CITY OF PORTLAND BUILDING PERMIT

Job ID: 2011-07-1696-SF

has permission to Build a New 2-story, 40'x24' Single Family Home with front porch and side deck/entry provided that the person or persons, firm or corporation accepting this permit shall comply with all of the provisions of the Statues of Maine and of the Ordinances of the City of Portland regulating the construction, maintenance and use of the buildings and structures, and of the application on file in the department.

ONE AND TWO FAMILY	PLAN REVIEW	CHECKLIST		
Soil type/Presumptive Load Value (Table R401.4.1)				
Component	Submitted Plans	Findings	Revisions	Date
STRUCTURAL				
Footing Dimensions/Depth (Table R403.1 & R403.1(1), (Section R403.1 & R403.1.4.1)	16" x 8" 24" x 24" x 12" pads 8" wall 4' to ledge pinned			
Foundation Drainage, Fabric, Damp proofing (Section R405 & R406)	Perimeter Drain open to basement	fabric, damp proof	OK	8/11/11
Ventilation/Access (Section R408.1 & R408.3) Crawls Space ONLY				
Anchor Bolts/Straps, spacing (Section R403.1.6)	/	?	OK	8/11/11
Lally Column Type (Section R407)	/	?	"	
Girder & Header Spans (Table R 502.5(2))	Max span 6'4"			
Built-Up Wood Center Girder Dimension/Type	3-2x12	? stai

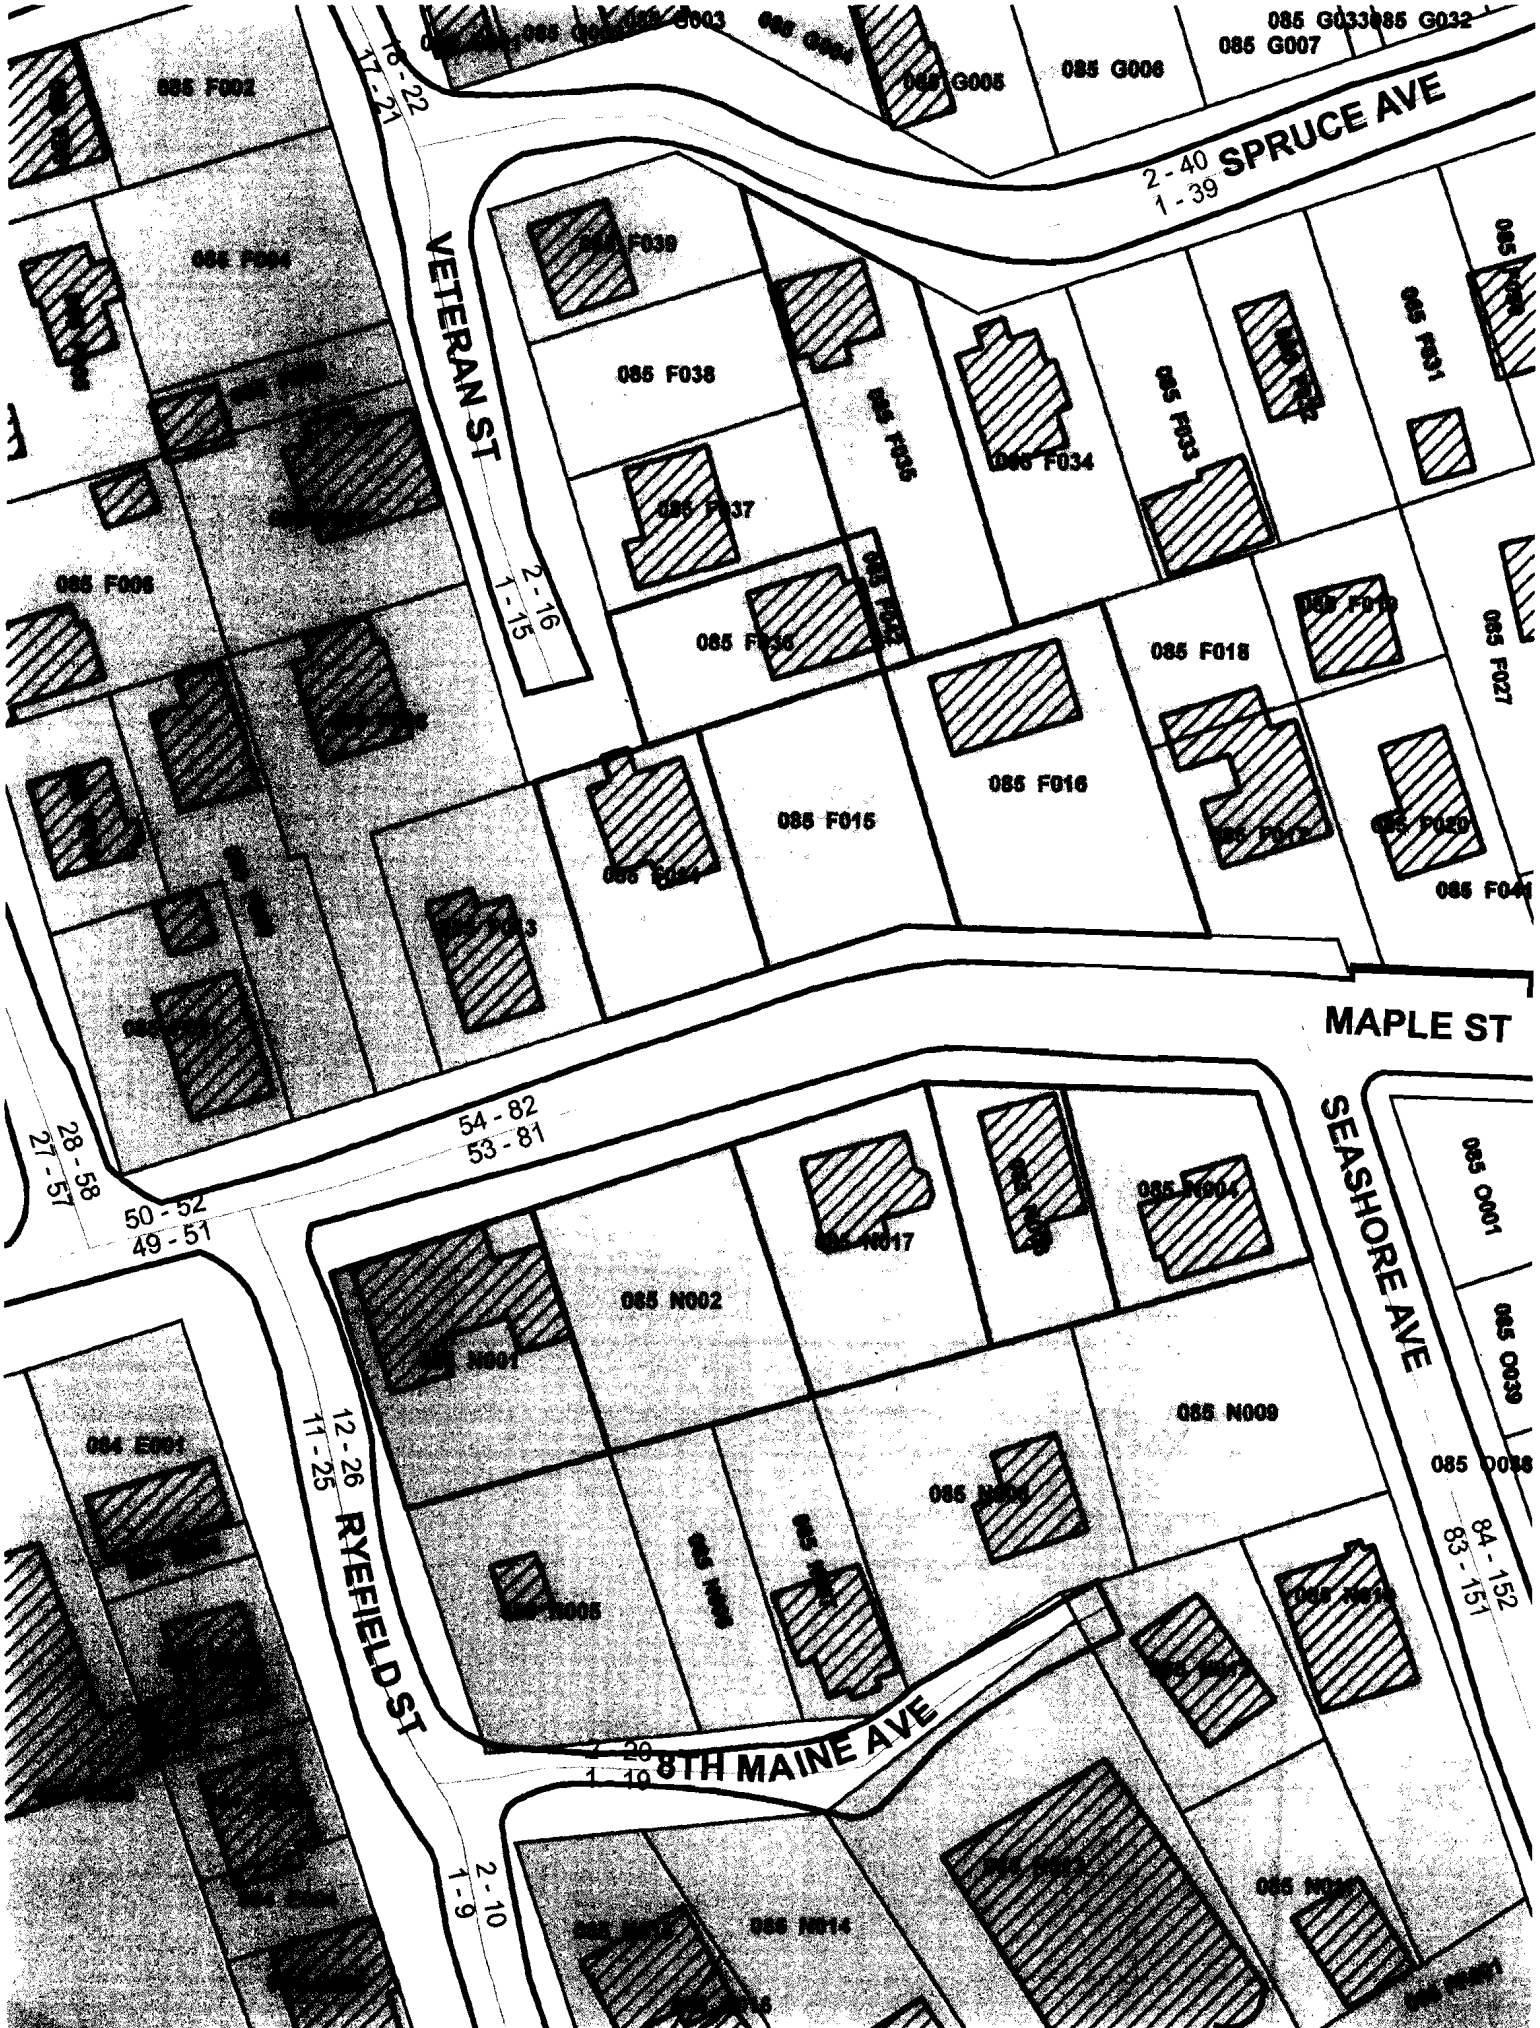
Second Floor Joist Species Dimensions and Spacing (Table R502.3.1(1) & Table R502.3.1(2))	2x12 16" O.C.			
Attic or additional Floor Joist Species Dimensions and Spacing (Table R802.4(1) and R802.4(2))	2x8 16" O.C. ceiling Joist Attic Main Roof 2x6 C.T. 32" O.C.

Pitch, Span, Spacing & Dimension (Table R802.5.1(1) - R 802.5.1(8)) Roof Rafter; Framing & Connections (Section R802.3 & R802.3.1)	4.10 - 5.23 : 12 2x10 16" OC 2x12 Ridge vertical stiffener partial roof			
Sheathing; Floor, Wall and roof (Table R503.2.1.1(1))	F-3/4" T & G, W-1/2" CDX, R-1/2 CDX			
Fastener Schedule (Table R602.3(1) & (2))	/	?	OK	(10)
Private Garage (Section R309) Living Space? (Above or beside) Fire separation (Section R309.2) Opening Protection (Section R309.1)	N/A			
Emergency Escape and Rescue Openings (Section R310)	/	?	OK 8/11/11	(17)
Roof Covering (Chapter 9)	#225 Asphalt			
Safety Glazing (Section R308)	stairwell	? Entry @ deck	8/11/11	(18)
Attic Access (Section R807)	/	? if needed	"	(19)
Chimney Clearances/Fire Blocking (Chap. 10)	N/A			
Header Schedule (Section 502.5(1) & (2))	All 3-2x10	Eng Specs on LVL'S	8/11/11	(20)
Energy Efficiency (N1101.2.1) R-Factors of Walls, Floors, Ceilings, Building Envelope, U-Factor Fenestration	Floor = R-15, FL = R-30, Wall R-20 ceiling R-49 U = .35	? How foundation detail	OK	(21)

Type of Heating System	/	? oil FHW per email 8/23/11	(12)
Means of Egress (Sec R311 & R312) Basement	Partial - w/ Egress doors		
Number of Stairways	4		
Interior	1		
Exterior	3		
Treads and Risers (Section R311.5.3)	/	?	OK (13)
Width (Section R311.5.1)			8/11/11
Headroom (Section R311.5.2)			
Guardrails and Handrails (Section R312 & R311.5.6 - R311.5.6.3)			
Smoke Detectors (Section R313) Location and type/Interconnected	/	? + CO	8/11/11 OK (14)
Draftstopping (Section R502.12) and Fireblocking (Section R602.8)			
Dwelling Unit Separation (Section R317) and IBC - 2003 (Section 1207)	N/A		9/14/11
Deck Construction (Section R502.2.1)	6x6 posts - 2-2x12 Beams 2x8 Joist over, 3' Rail-4"	Need Lateral connection detail Need side porch foundation detail	(15)

6'x16'-sona @ 8' o.c.
